FRIDAY MAILING

5/2/97

SILO 3 INFORMATION NEEDS

**RESPONSE TO FERNALD CITIZENS TASK FORCE COMMENTS ON THE
DRAFT SILO 3 ALTERNATIVES EVALUATION REPORT
October 17, 1996 (cont'd)**

FIGURE 2
ESTIMATED DISPOSAL VOLUME FOR VITRIFIED SILOS 1 AND 2
RESIDUES AND STABILIZED SILO 3 RESIDUES

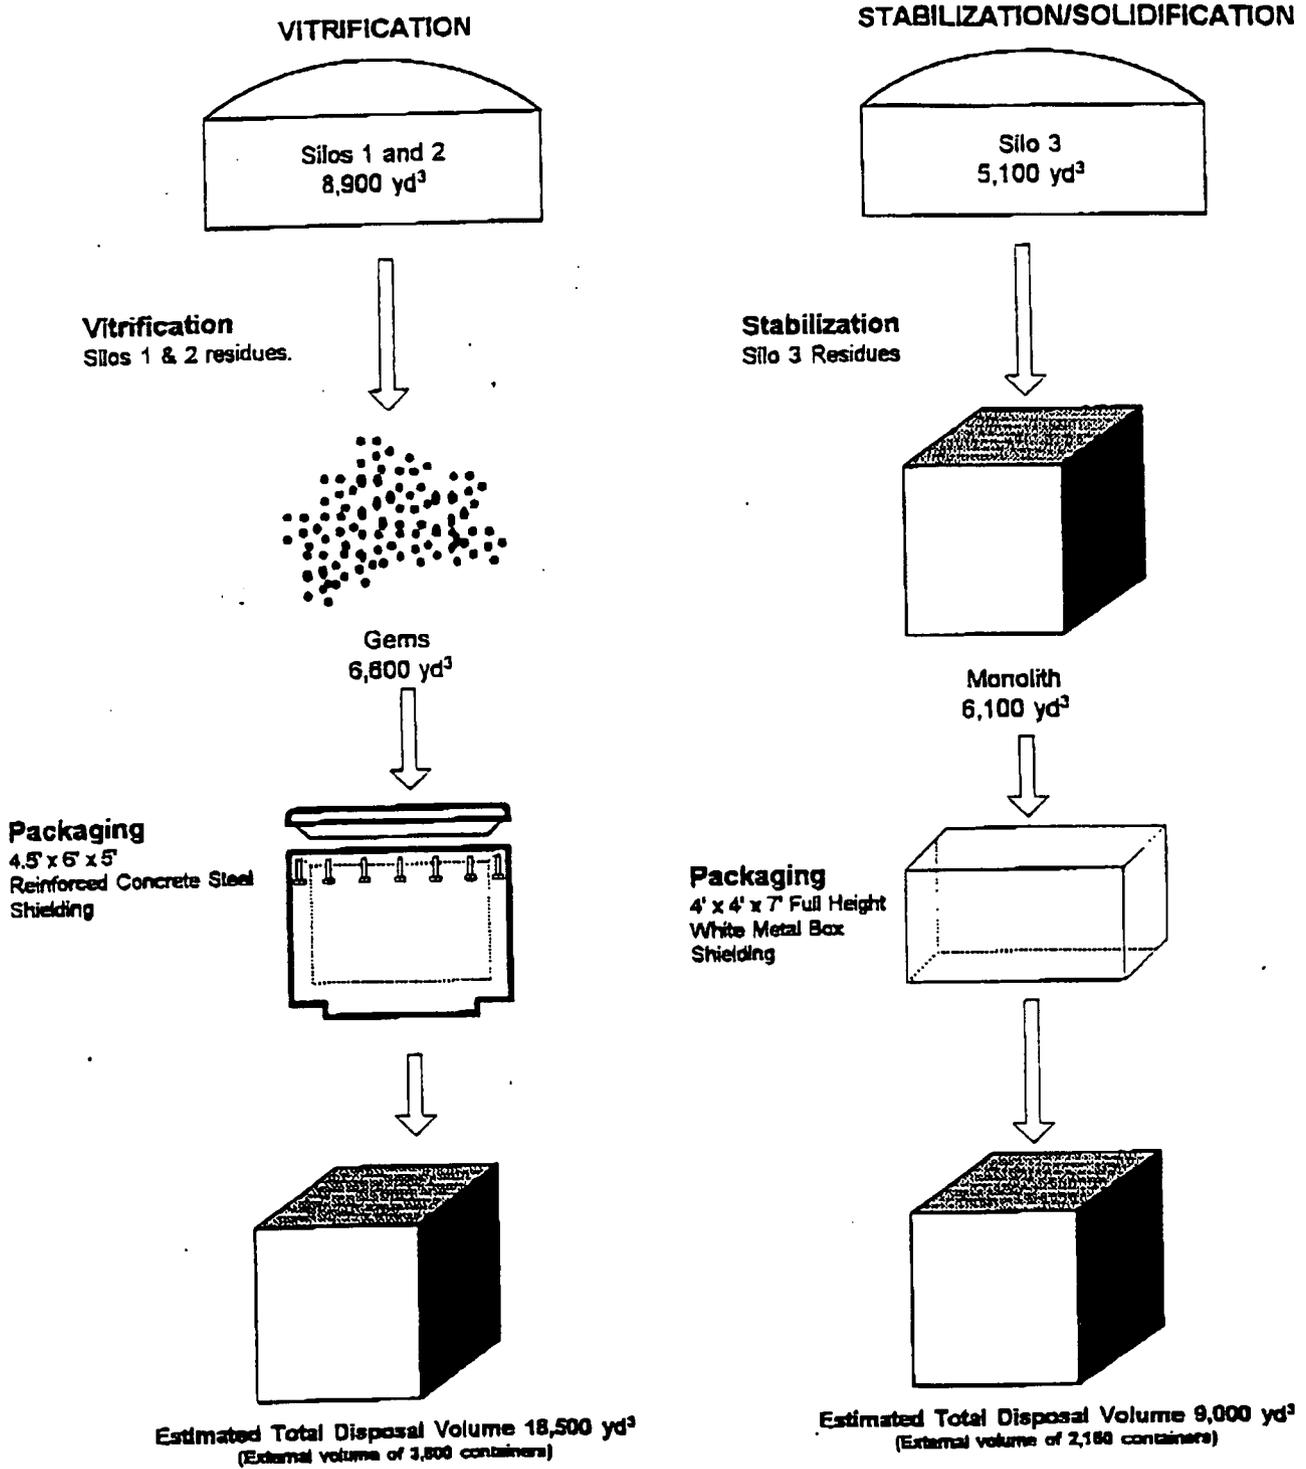
Comment: Cementation does not result in as stable a waste form as vitrification and this has ramifications on both transportation and disposal. We would like a detailed analysis for all constituents and compounds in Silo 3 comparing the effectiveness of vitrification and cementation, the risks of transportation, and compliance with waste acceptance criteria. There is also the possibility that Silo 3 wastes could be treated off site. In order for this to be a viable option, an analysis of transportation of the untreated waste will be needed.

that leave the FEMP. Although vitrification results in a reduction in treated waste volume, this reduction is offset by the increase in disposal volume associated with the concrete container required to keep radiation levels ALARA. Figures 1 and 2, in Attachment 2, present a volume comparison for the vitrified Silos 1, 2, and 3 wastes versus vitrified Silos 1 and 2 wastes and cement stabilized Silo 3 wastes, respectively. These comparisons are based on data presented in Volume 2 of 2 of the Draft Final Evaluation of Silo 3 Wastes Alternatives Report (December 1996).

A similar evaluation comparing the total disposal volume for vitrified Silo 3 wastes (only) and cement stabilized Silo 3 wastes (only) has also been conducted. This information is presented in Volume 1 of 2 of the Draft Final Evaluation of Silo 3 Wastes Alternatives Report and is included as Figure 3 of Attachment 2 in this comment response document. While there is a three-fold increase in total disposal volume associated with cement stabilized Silo 3 wastes versus vitrified Silo 3 wastes (separate from Silos 1 and 2 wastes), the benefits of the volume reduction are outweighed by the technical challenges posed by vitrification of the Silo 3 wastes as discussed below.
